SKEP III Home Office Support Site Visit Report

Consultant	Wahib Medanat Consultant Engineer	Rep No.	13-14092021
Contractor	Derar Saraireh & Sons for Engineering & Contracting	Tender No.	(11/2019/USAID/SKEP/3/S) Schools for a Knowledge Economy Project (SKEP) - Phase (3) Package (1, 2)
Site Name	Khadija Bint Khwailed Basic Mixed School- Shouna Janoubia	Day/ Date	Tue. 14/09/2021
Duration of Project	450 Calendar Days	Total Project Budget	9,789,417.840 JD

(Figure: 08 & 09)

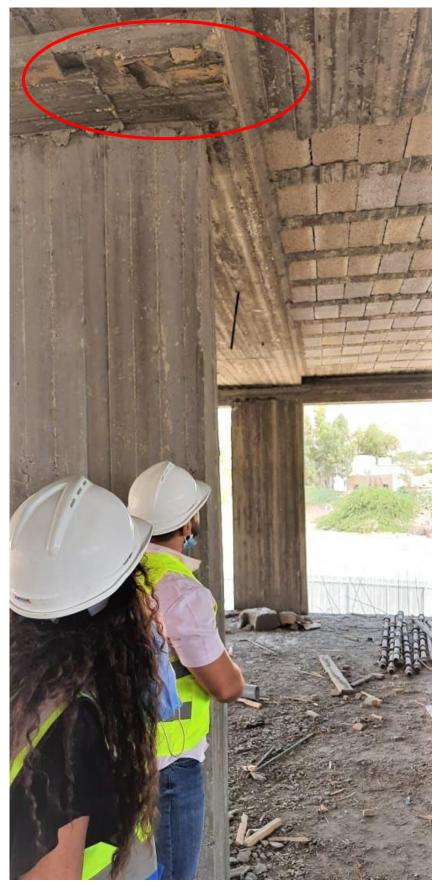
A comment was given about the left wooden pieces at the structure elements (mainly the slab). The Contractor promised to remove those pieces before plastering

(Figure: 11 & 12)

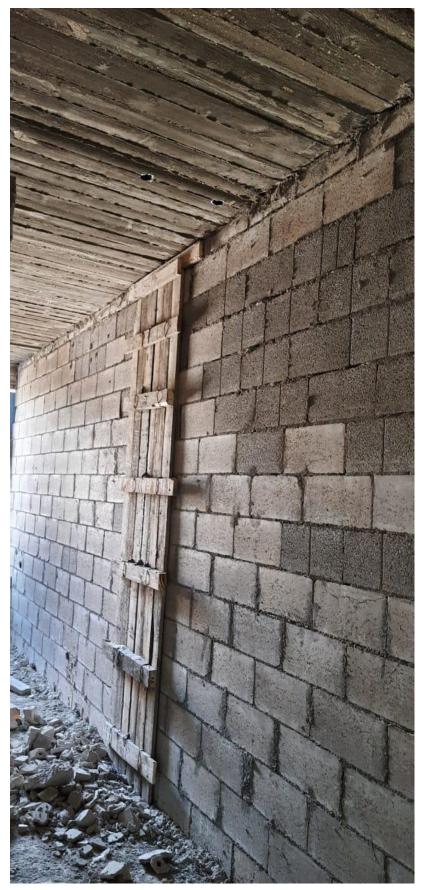
It was observed that the Contractor executed a stiffener column within a long block wall in accordance to previous remark by the supervision team

(Figure: 13)

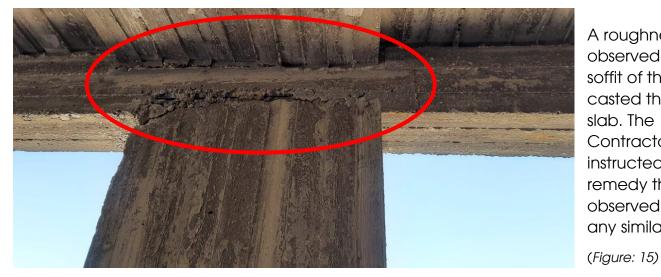
A roughness was observed at the soffit of the lately casted third floor slab. The Contractor was instructed to remedy the observed parts and any similar parts
